GREEN VALLEY RANCH EAST
PRELIMINARY SITE PLAN #5
TITLE: KEYMAP
DATE: March 24, 2022

GREEN VALLEY RANCH EAST
PRELIMINARY SITE PLAN #5
TITLE: LANDSCAPE PLAN
DATE: March 24, 2022

GREEN VALLEY RANCH EAST
PRELIMINARY SITE PLAN #5
TITLE: LANDSCAPE DETAILS
DATE: March 24, 2022

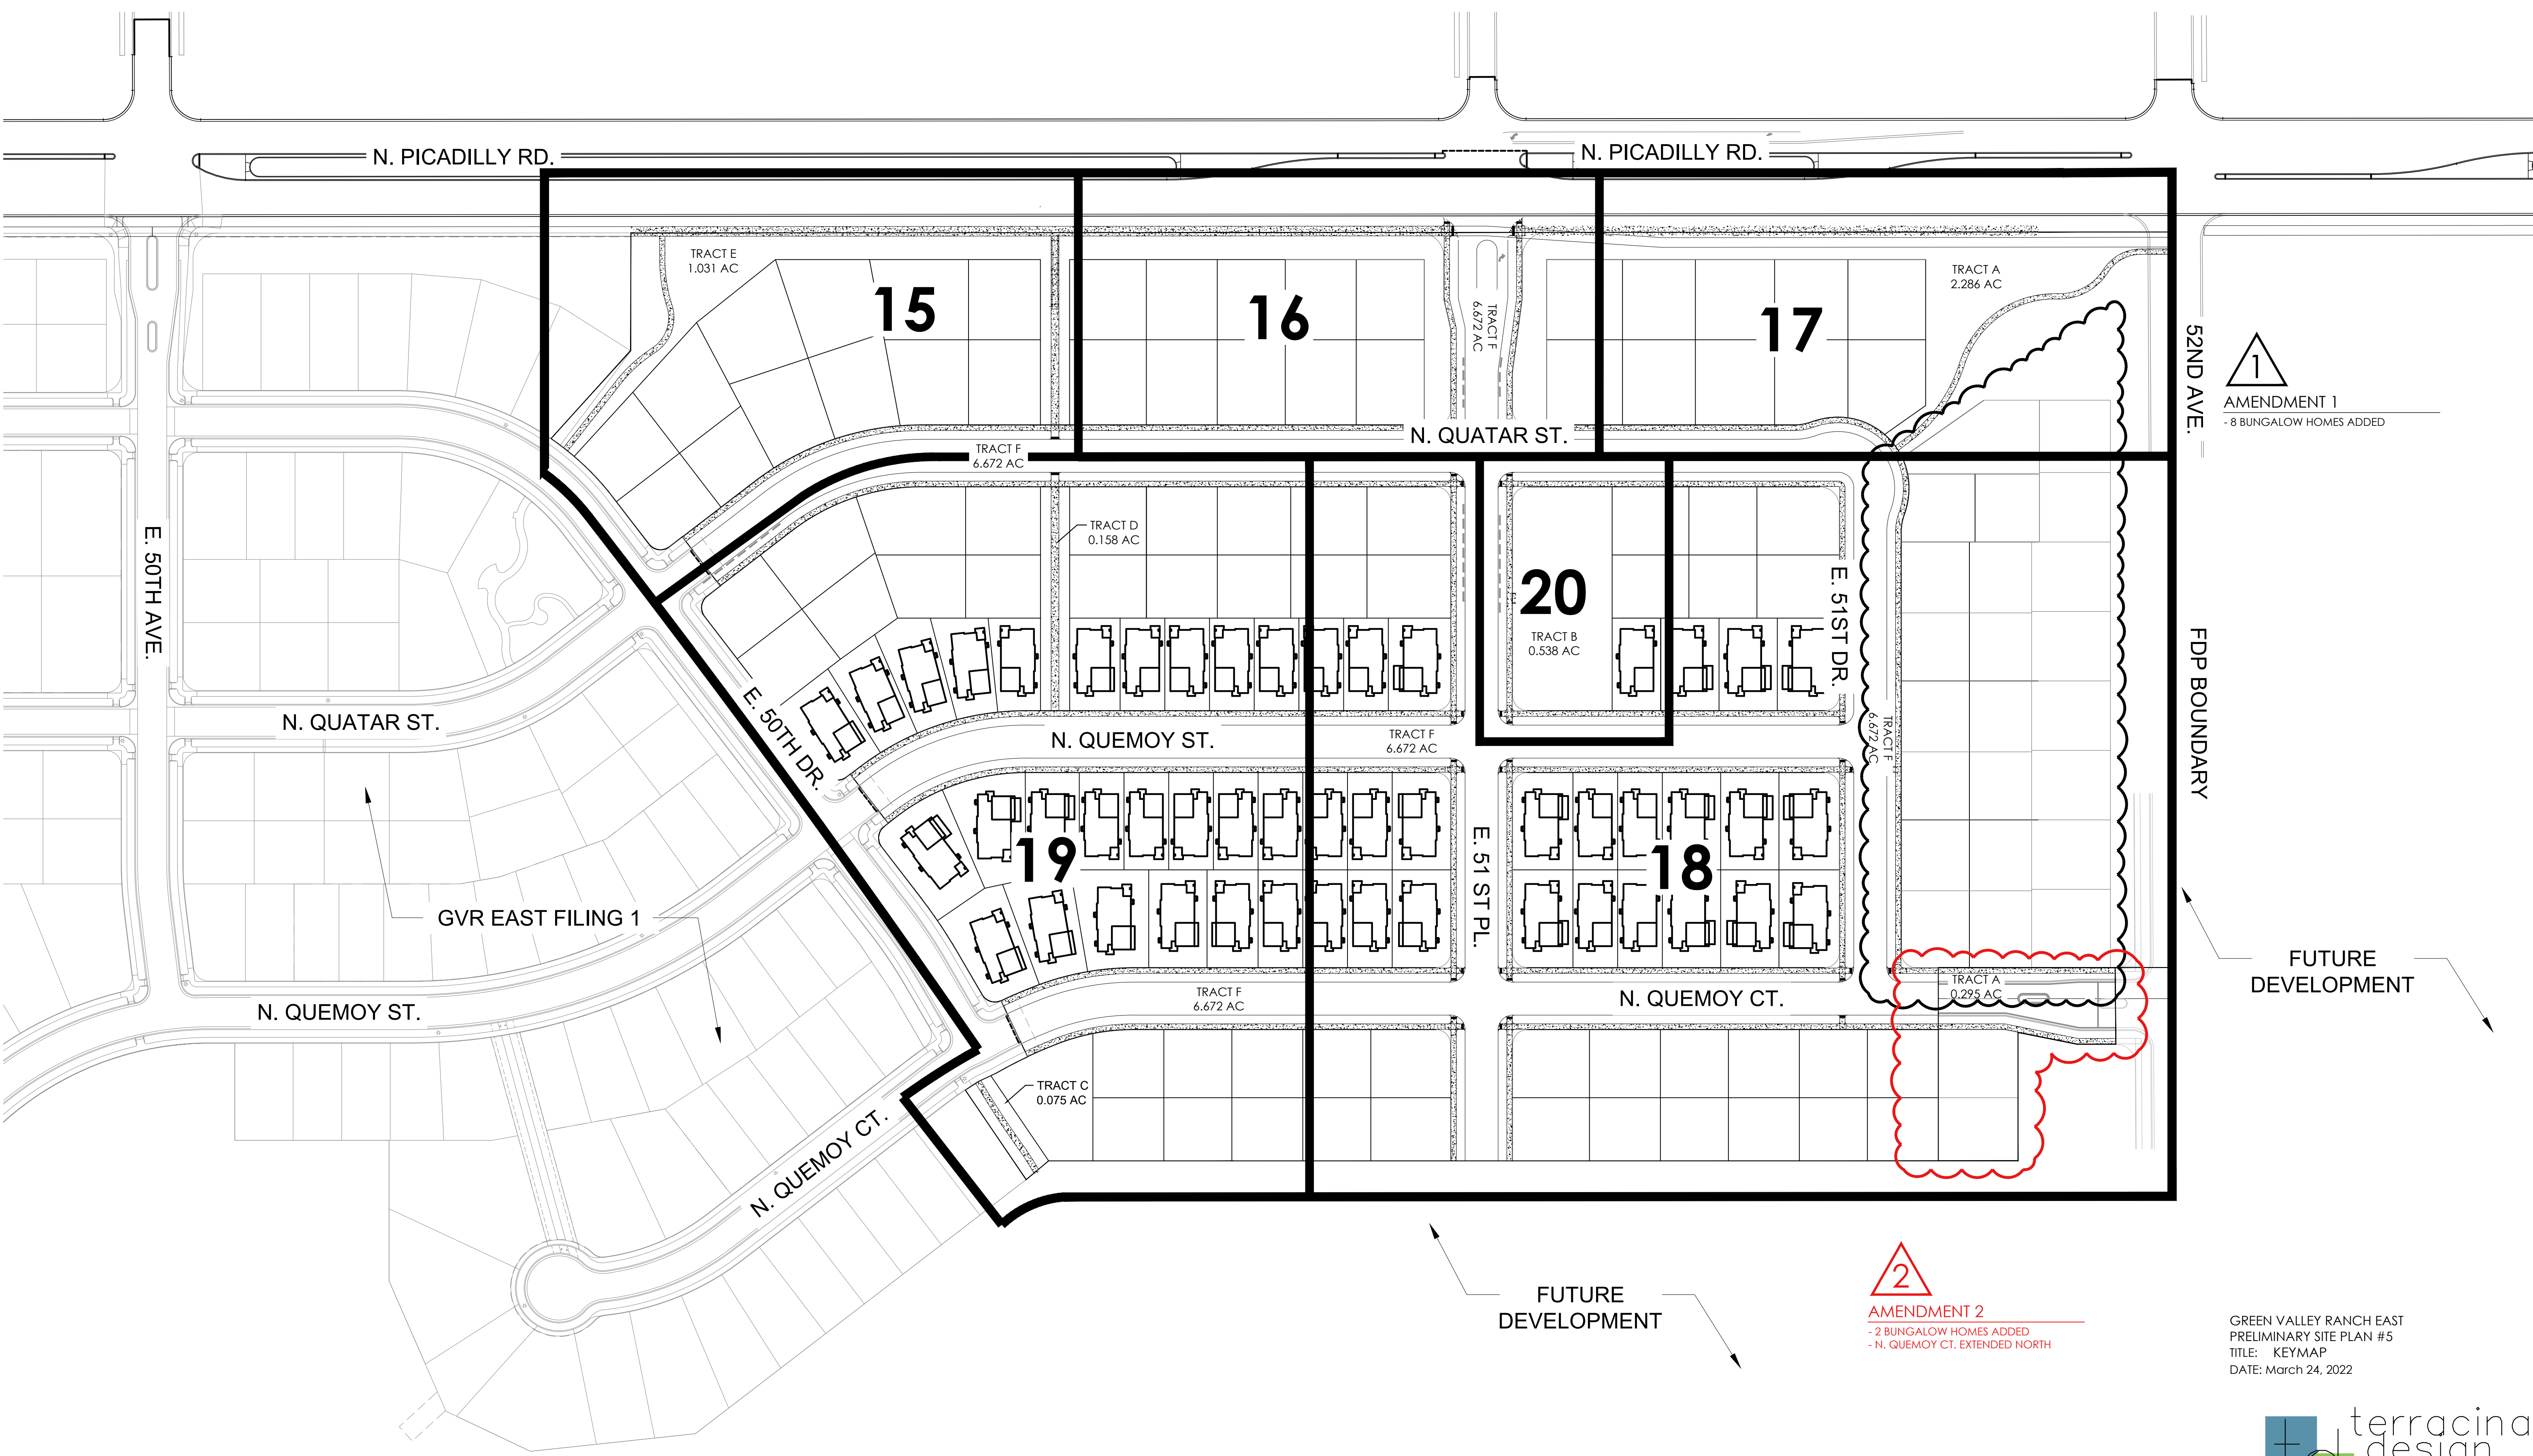
1
AMENDMENT 1
- 8 BUNGALOW HOMES ADDED

2
AMENDMENT 2
- 2 BUNGALOW HOMES ADDED
- N. QUEMOY CT. EXTENDED NORTH

SHEET 18 OF 28

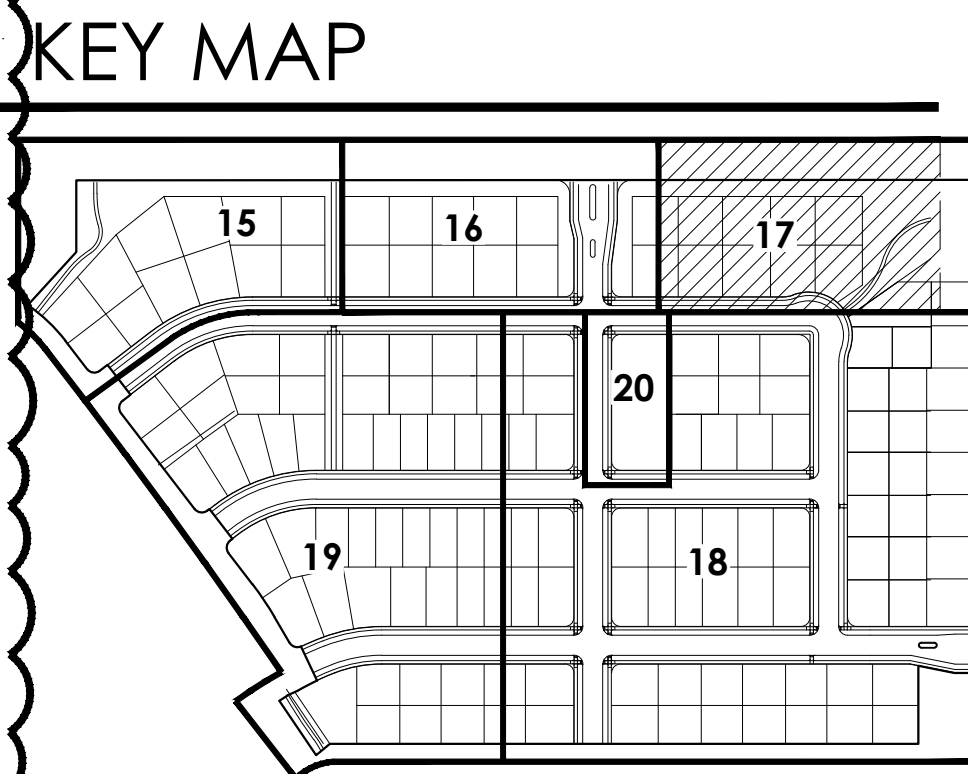
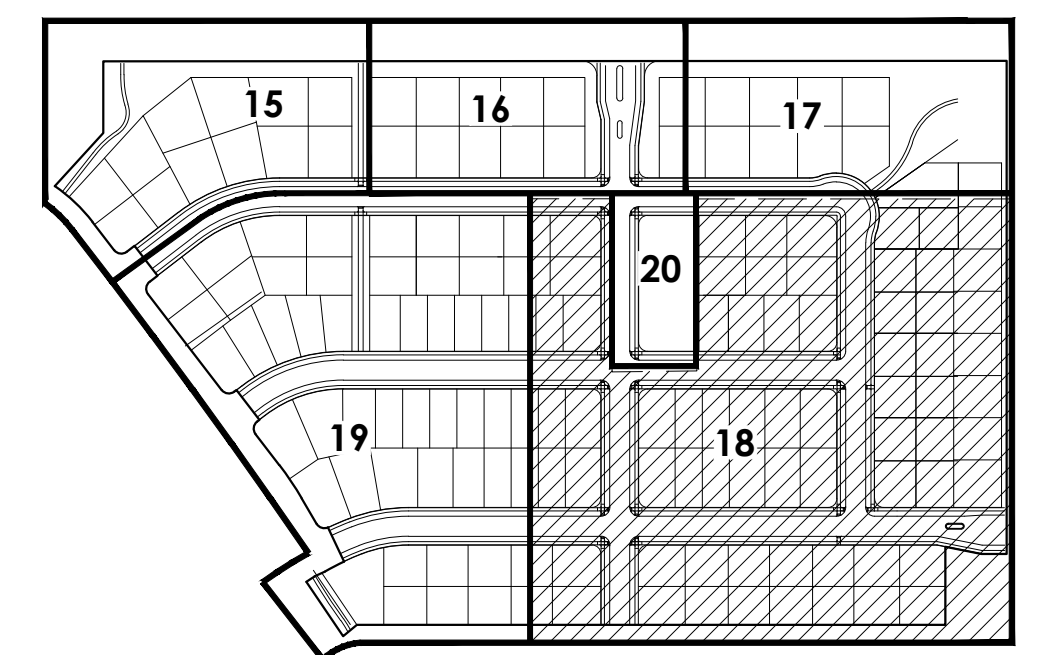
AMENDMENT 1
- 7 BUNGALOW HOMES ADDED
- TREES AND NATIVE SEED ADDED

AMENDMENT 1

AMENDMENT 2

- 2 BUNGALOW HOMES ADDED
- N. QUEMOY CT. EXTENDED NORTH

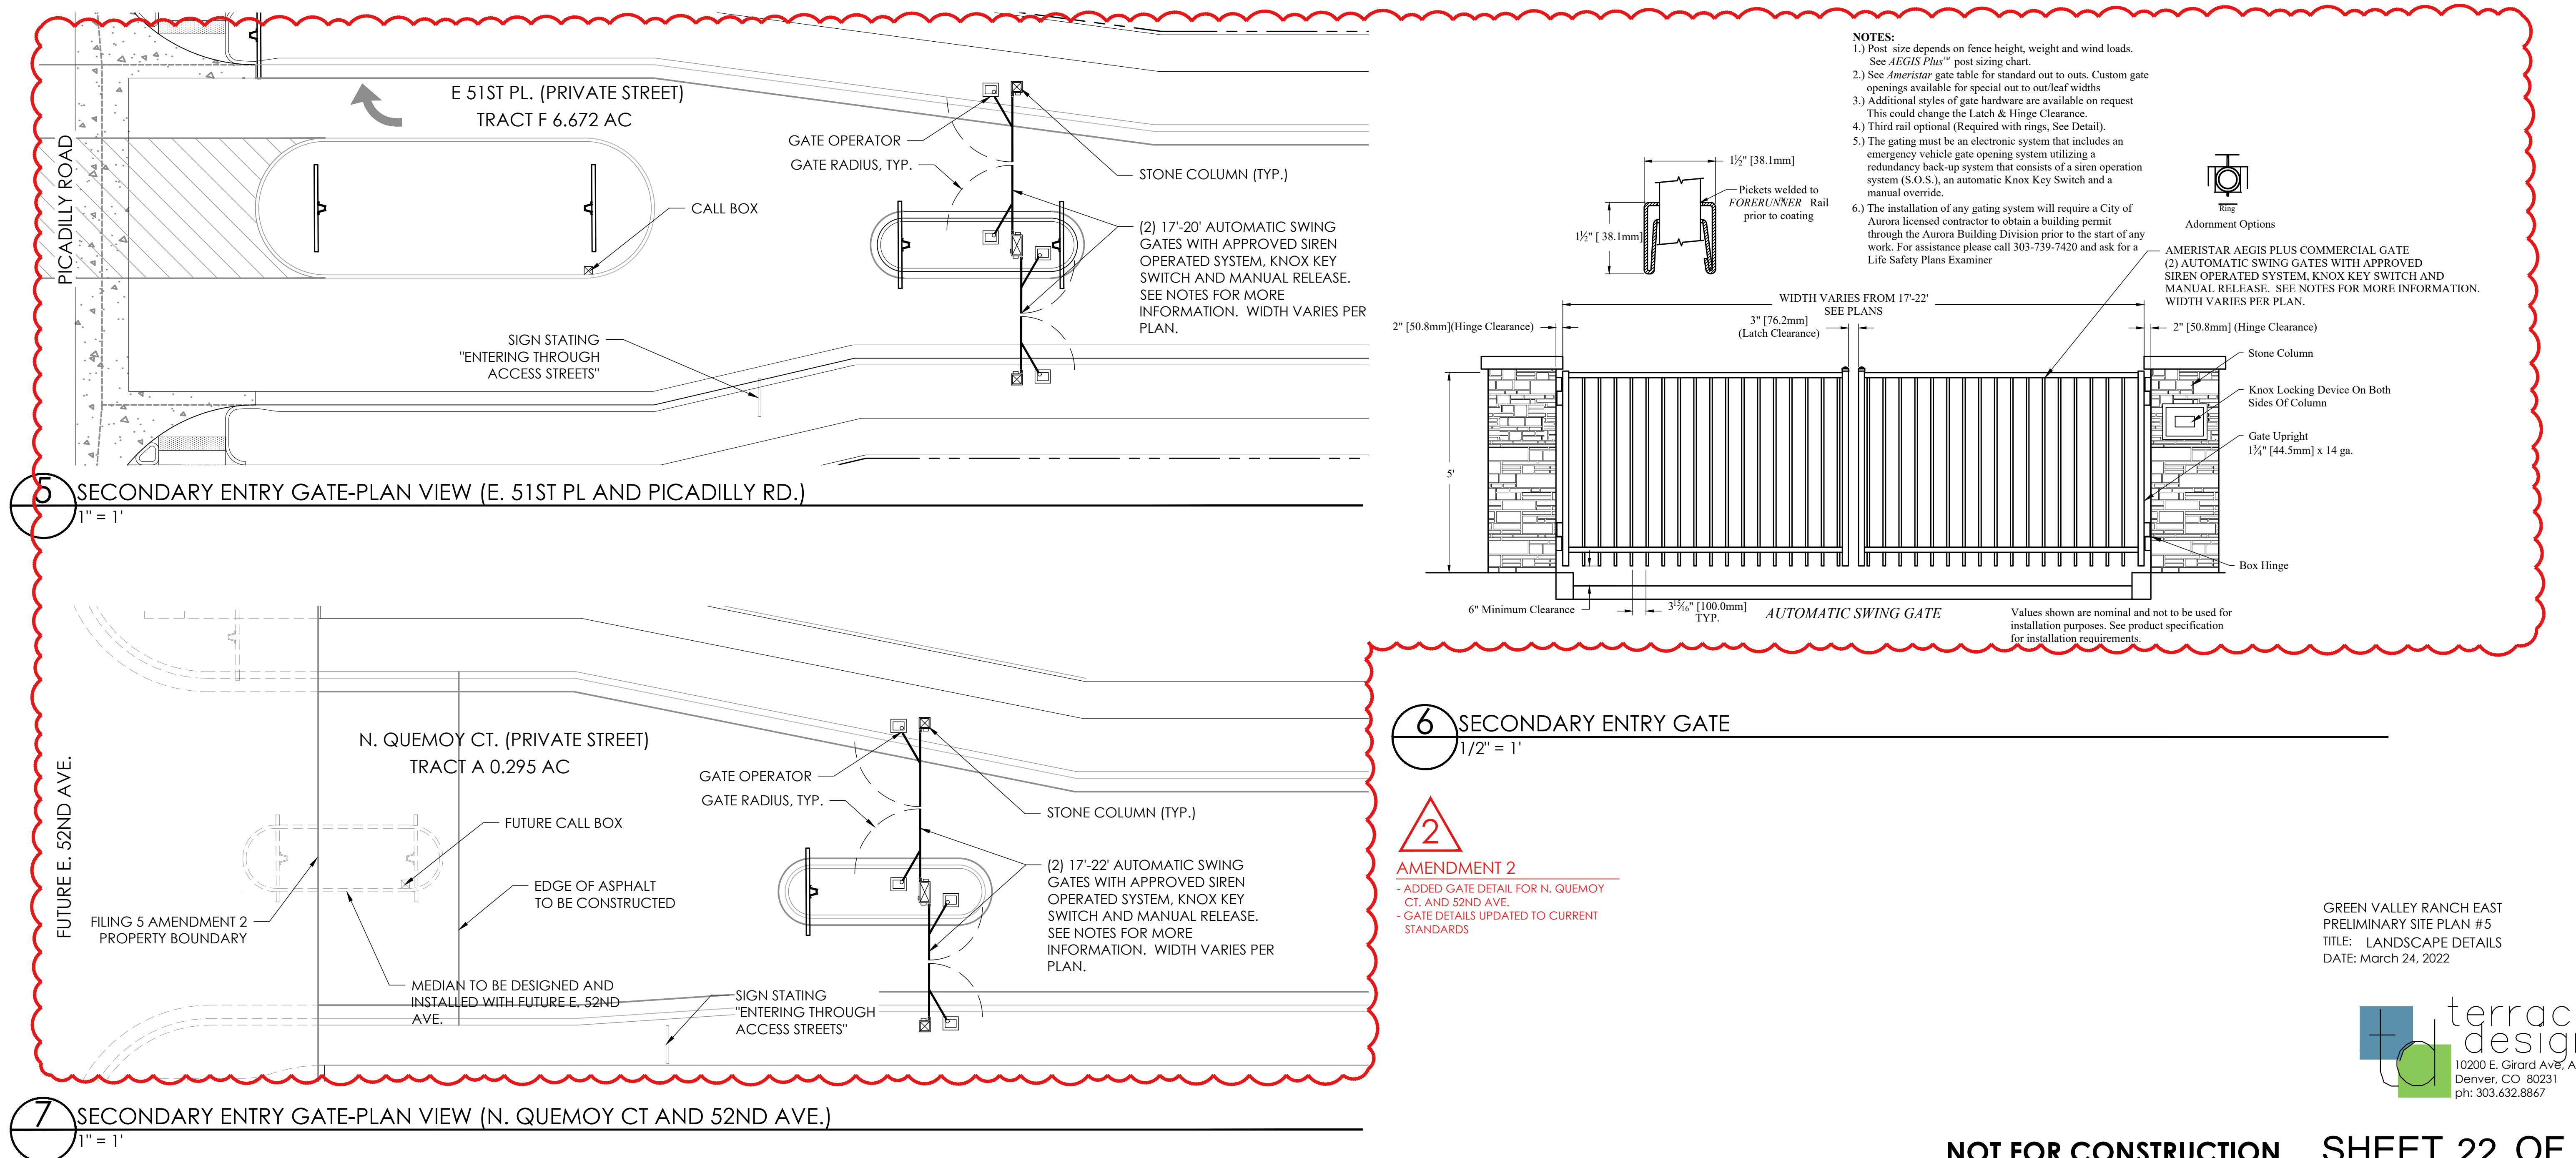
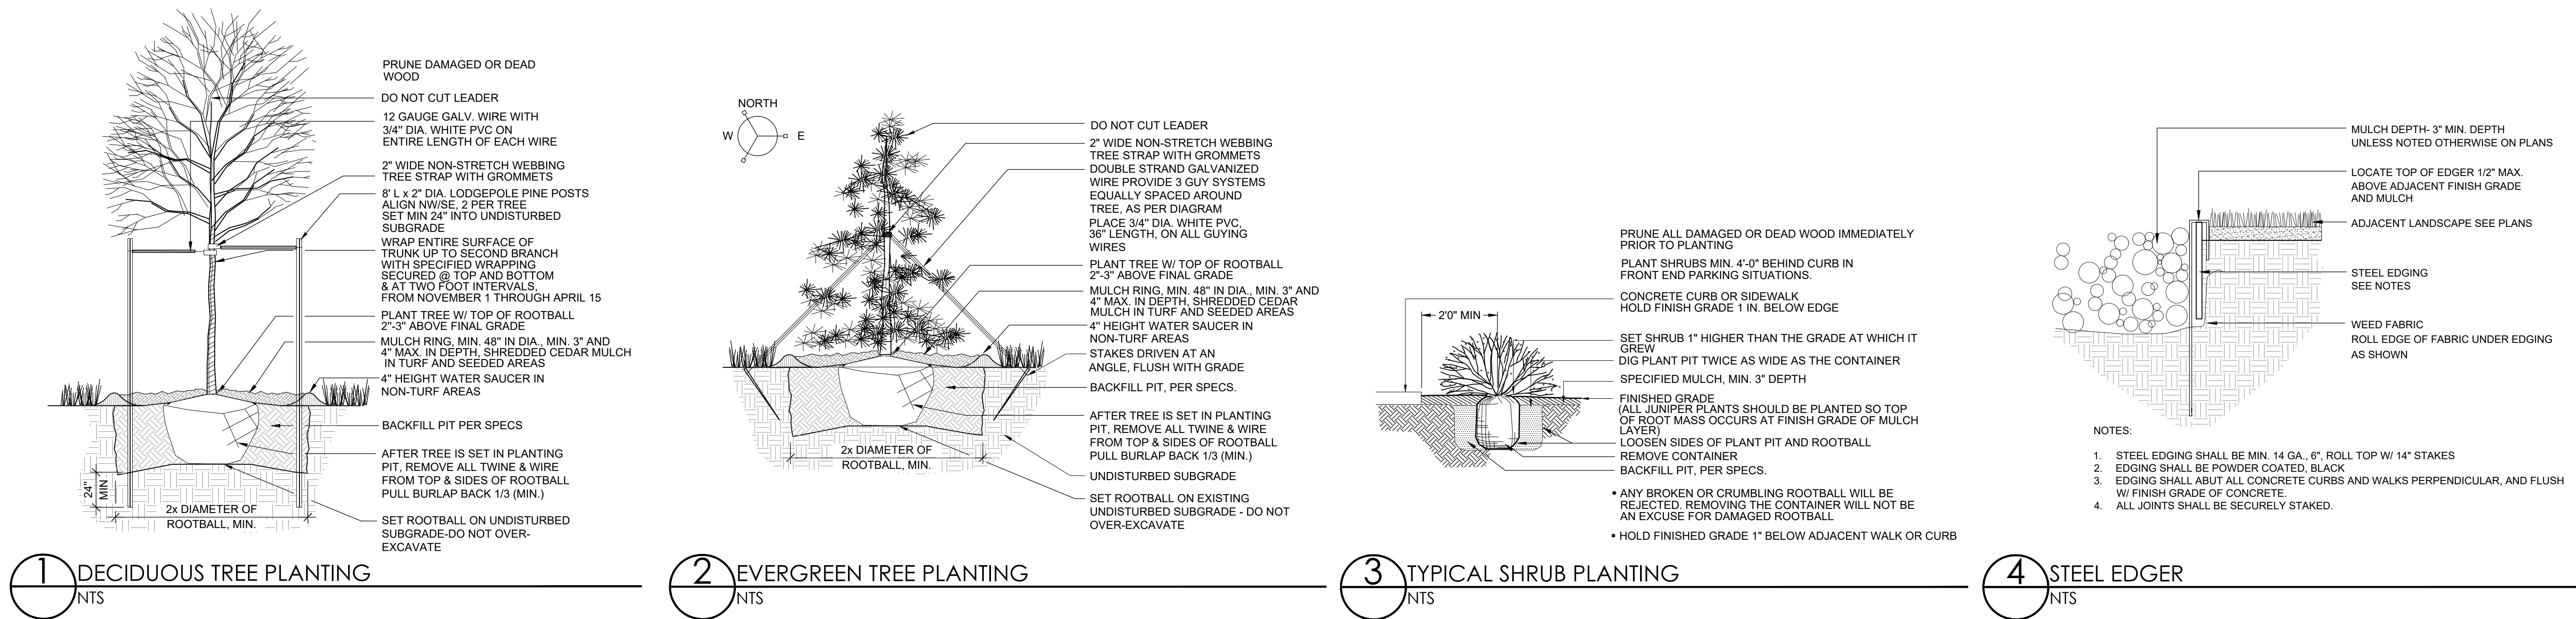
AMENDMENT 2

- TREES ADDED TO N. QUEMOY CT.
- SITE DATA UPDATED TO INCLUDE AMENDMENT AREA
- PLANT COUNTS UPDATED
